PLAN COMMISSION MEETING NOTICE AND AGENDA Tuesday, March 15, 2022 6:00 PM

REPORT TO THE PLAN COMMISSION

Date: February 25, 2022
To: Caroline Brzezinski, Interstate Partners
From: Nick Fuchs, Planner & Community Development Director
RE: Staff Comments – Ridgeview Apartments development

EAST ELEVATION
SCALE: 1' = 1/16"

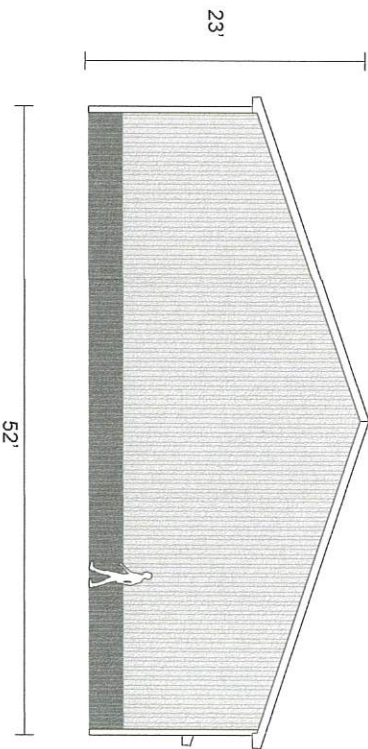
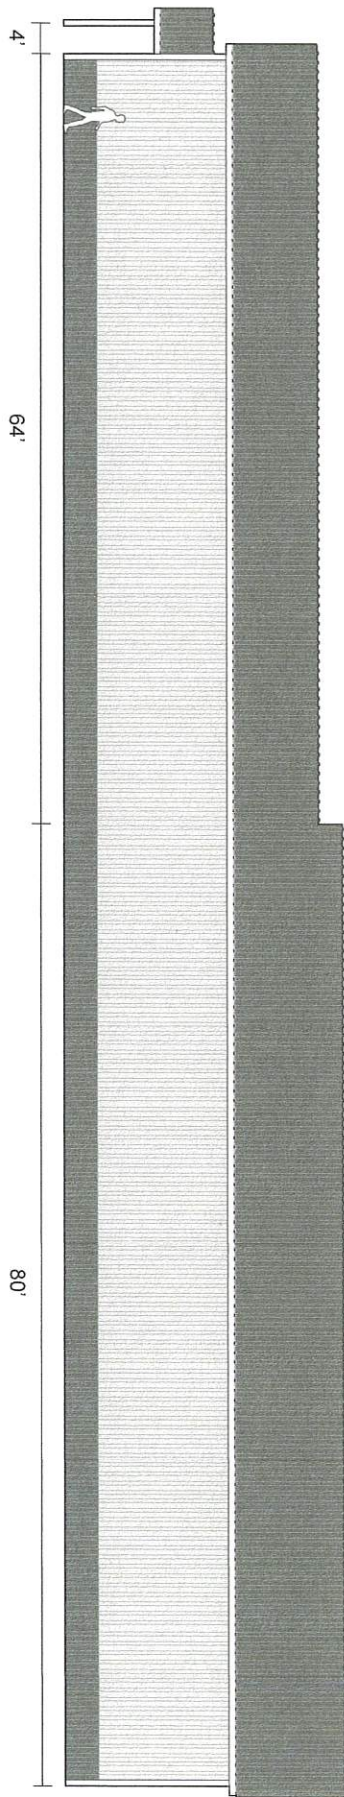
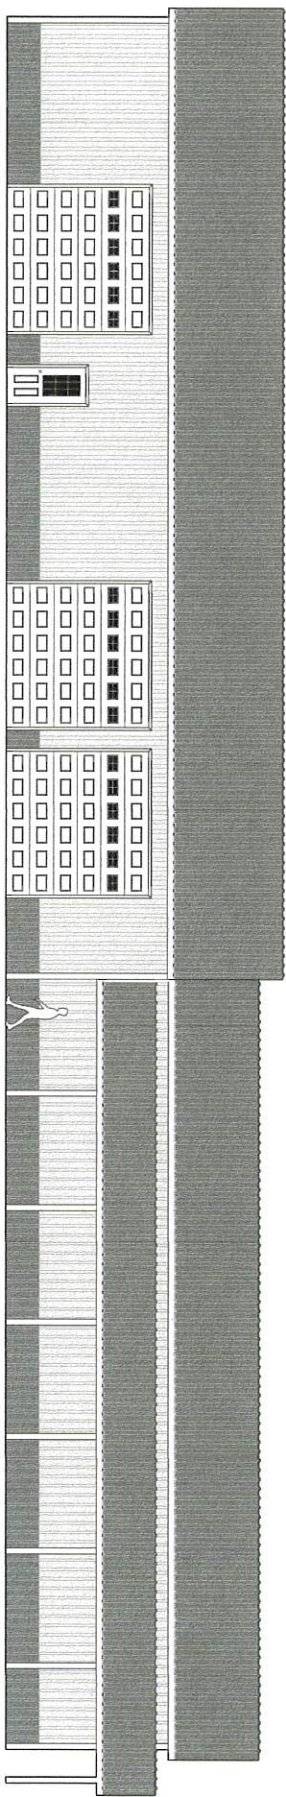
The proposed building consists of steel siding with light gray walls, a charcoal gray roof and white trim. Based upon previous Plan Commission discussions, staff recommends that the building be constructed of the same type of siding as the principal dwelling on the property. This is also a requirement for accessory buildings on properties zoned as single-family residential. Per the Assessor’s records, the home on the property consists primarily of a wood or cement board siding.

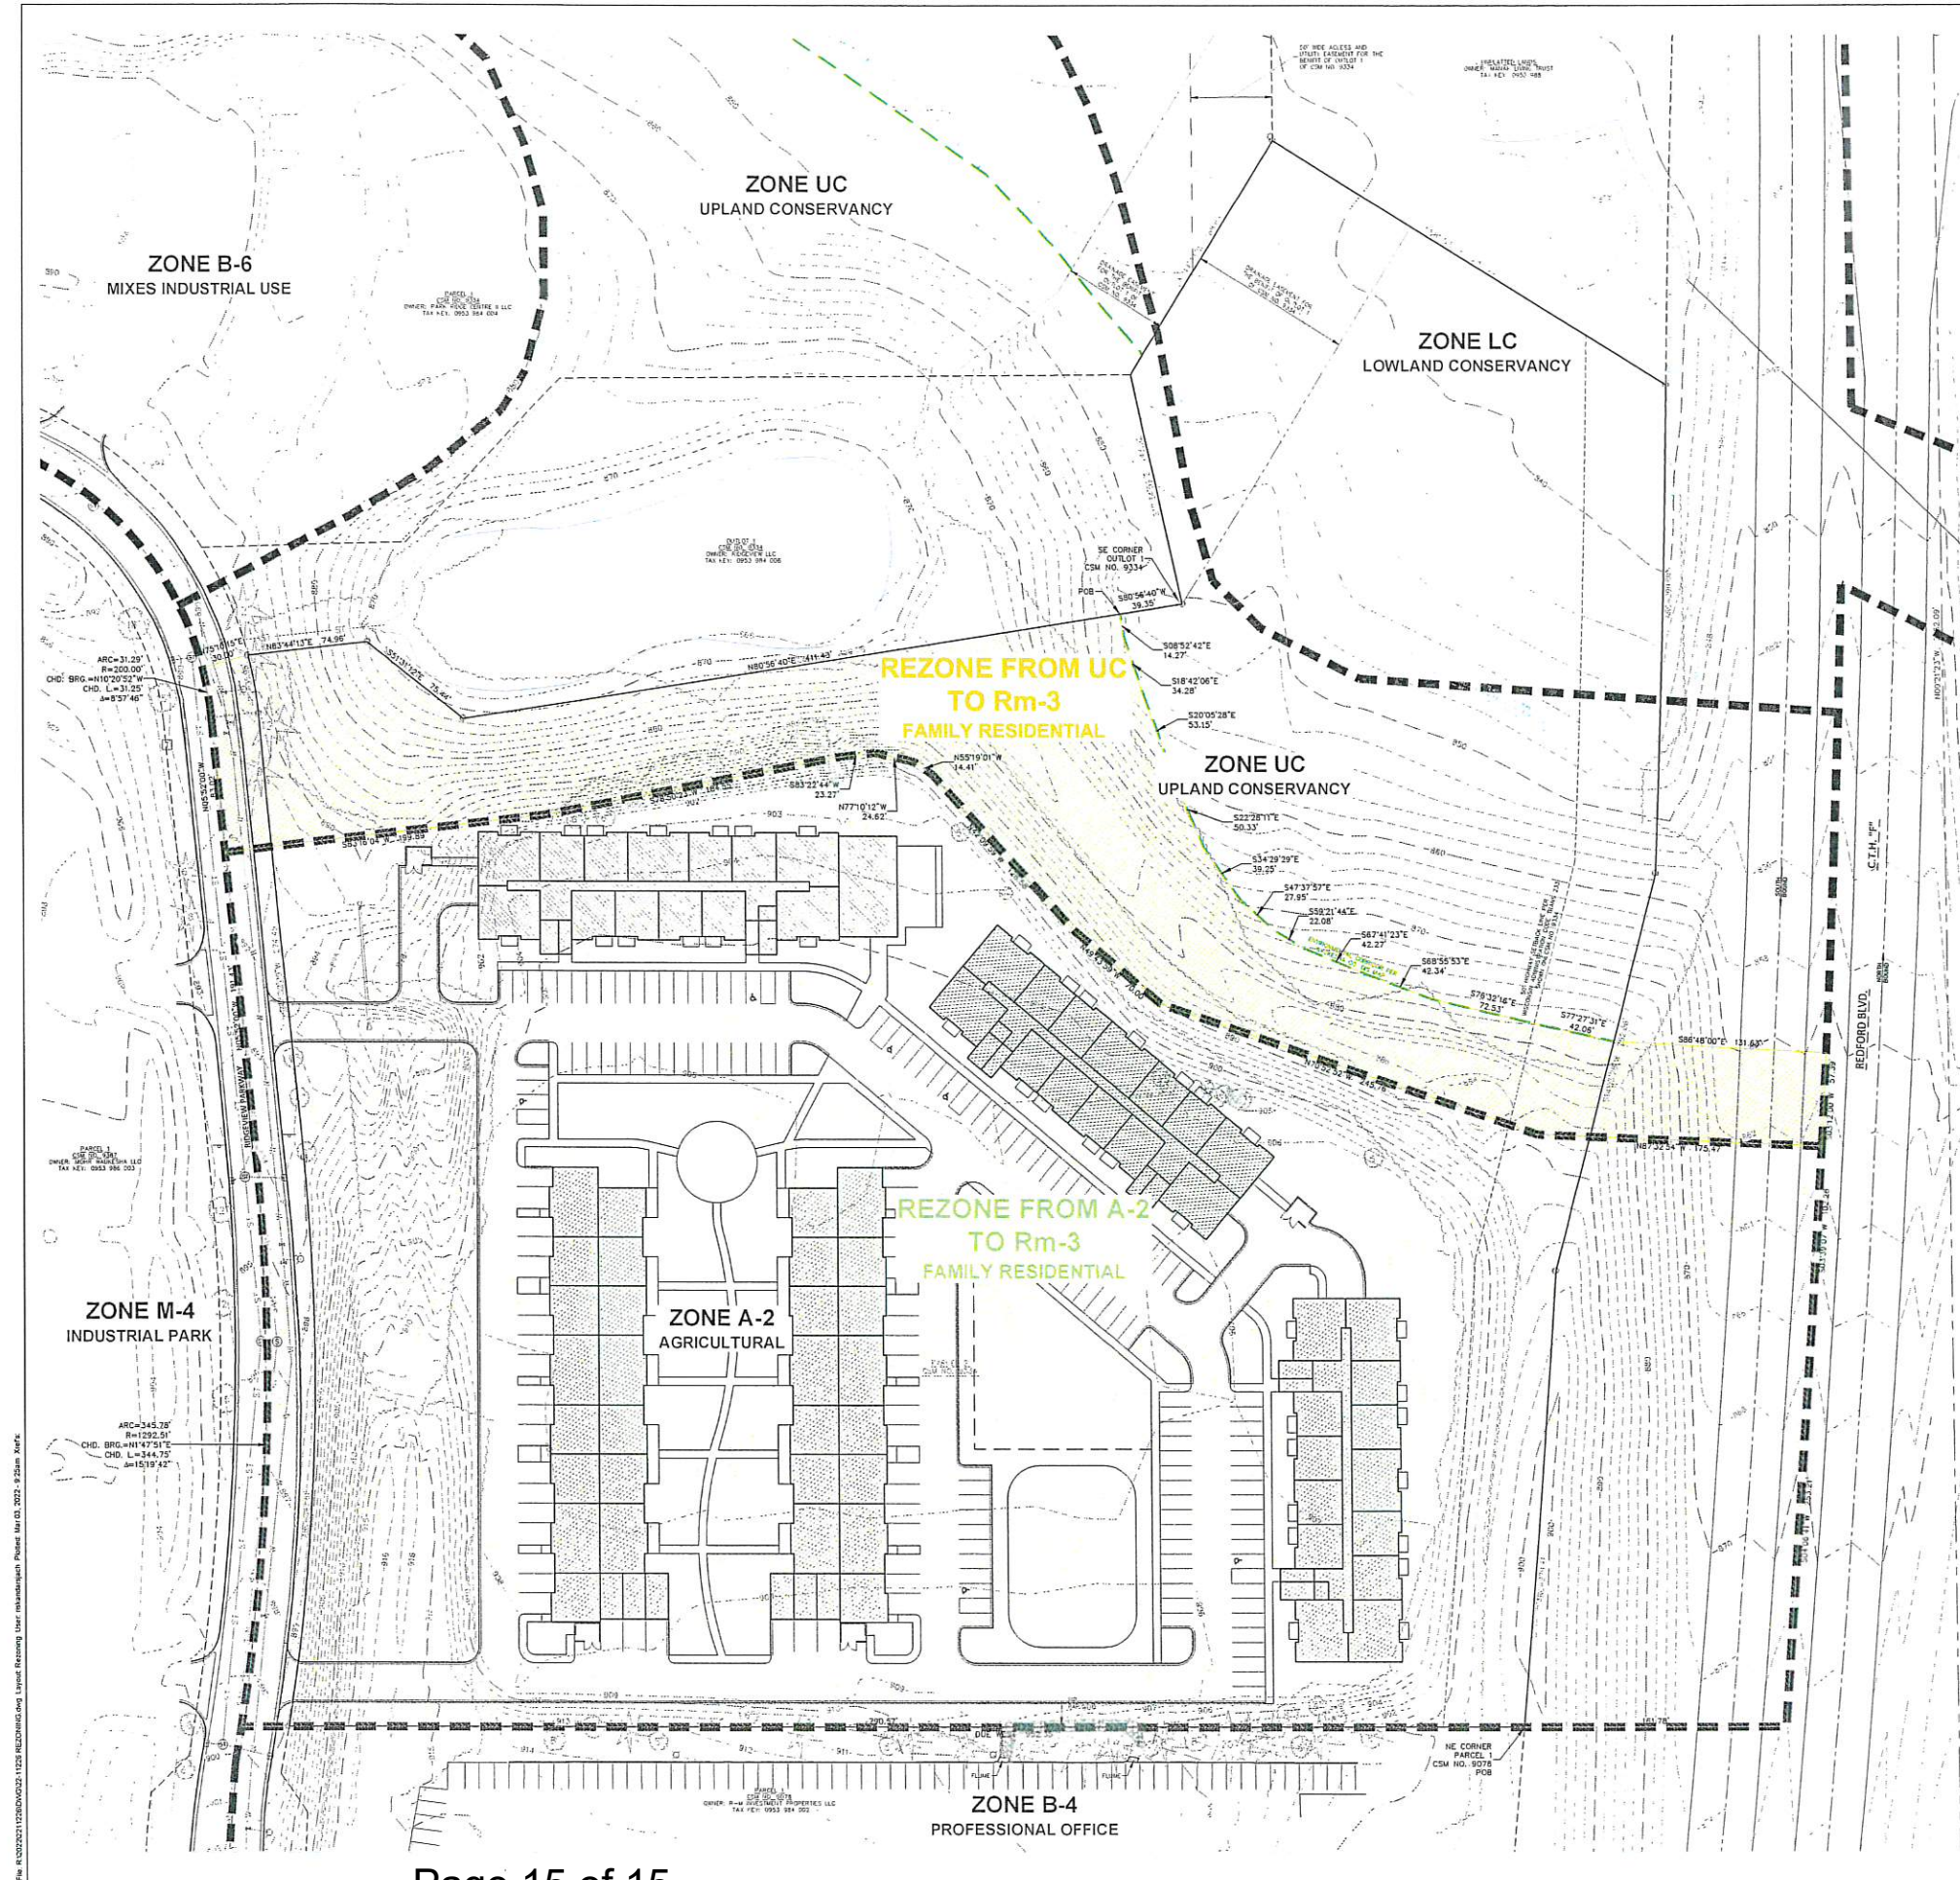
3. Please dimension the building separation on the site plan. Are all buildings at least 40-feet apart?
 - a. **Buildings have been dimensioned on Sheet C-100: Conceptual Site Plan, and are at least 40' apart.**
4. Are the minimum unit sizes of the Rm-3 District met (see below)?
 - a. **Proposed individual unit sizes have been added to sheets A100 & A101.**

5. Please provide site calculations. Note the Rm-3 District requires that the buildings not exceed 25% of the developable area of the site.

- a. Calculation on Sheet C-100: Conceptual Site Plan
6. Also, the site data table should include the net density calculation. Note that the site area for net density may not include more than 20% of any wetland areas onsite.

- a. Data Table on Sheet C-100: Conceptual Site Plan
7. Please show the required building and parking setbacks on the site plan.
 - a. Shown on Sheet C-100: Conceptual Site Plan and Sheet C-200: Conceptual Grading and Utility Plan

8. Please dimension typical parking stall on the site plan. Note parking spaces must be a minimum of 180 square feet.
 - a. Shown on Sheet C-100: Conceptual Site Plan

9. Note that paving must comply with Section 17.0601c. of the Zoning Code.
 - a. Noted. Curbing and asphalt pavement is shown on Sheet C-100: Conceptual Site Plan

10. It is recommended that the site plan and landscape plan show a limit of disturbance boundary on the plan.
 - a. Limit of disturbance shown on Sheet C-100: Conceptual Site Plan and L-100: Landscape Plan

SHEET NUMBER:
EX-1

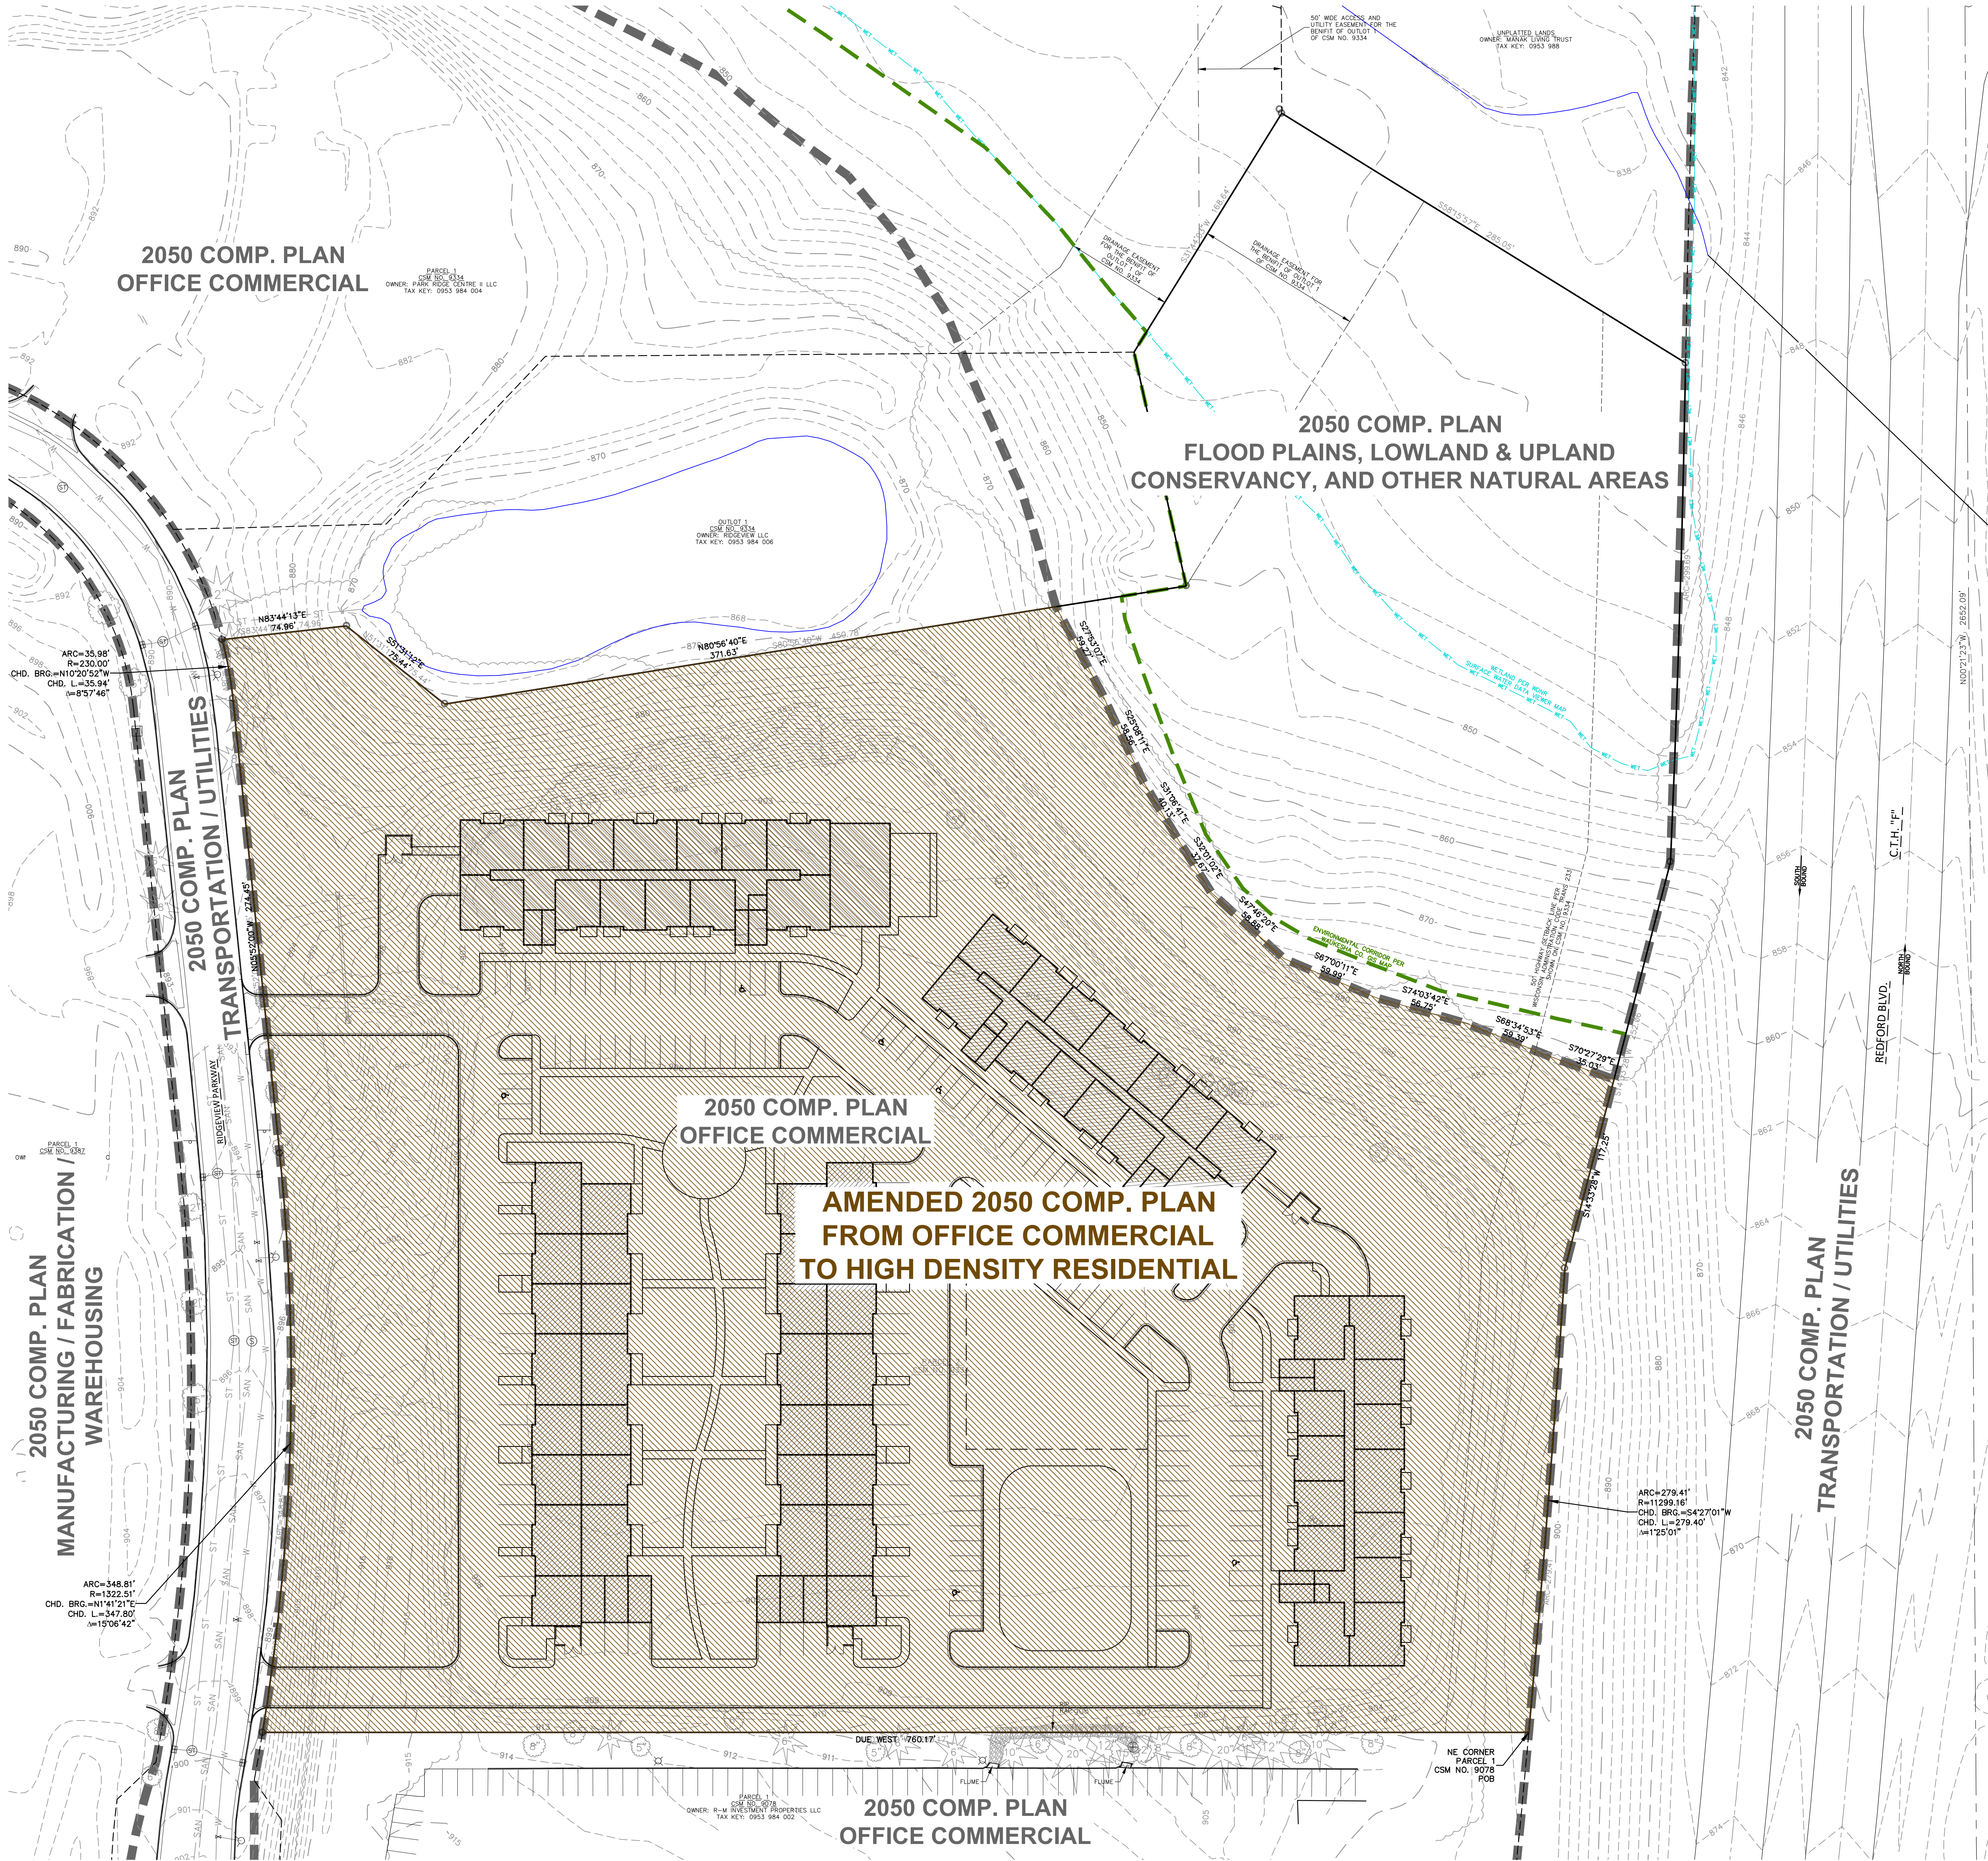
1. Please revise the project narrative to state that the rezoning is from the A-2 District, not B-6.
 - a. **Project Narrative has been revised.**
2. Please provide a rezoning and comprehensive master plan amendment exhibit. These maps should state and show the boundaries of the existing and proposed zoning and land use designations.
 - a. **Exhibit EX-1: Rezoning Exhibit drafted**
 - b. **Exhibit EX-2: Comp. Plan Amendment Map drafted**

Note the Comprehensive Master Plan Amendment Application is requesting to amend the future land use designation from “Office Commercial” to “High Density Residential.” The natural resource areas must be designated as “Flood Plains, Lowland & Upland Conservancy, and Other Natural Areas.”

The Rezoning Application requests to change the zoning from A-2 Agricultural District to Rm-3 Multiple-Family Residential District. Natural resource areas must be zoned UC Upland Conservancy District and LC Lowland Conservancy District as may be appropriate.
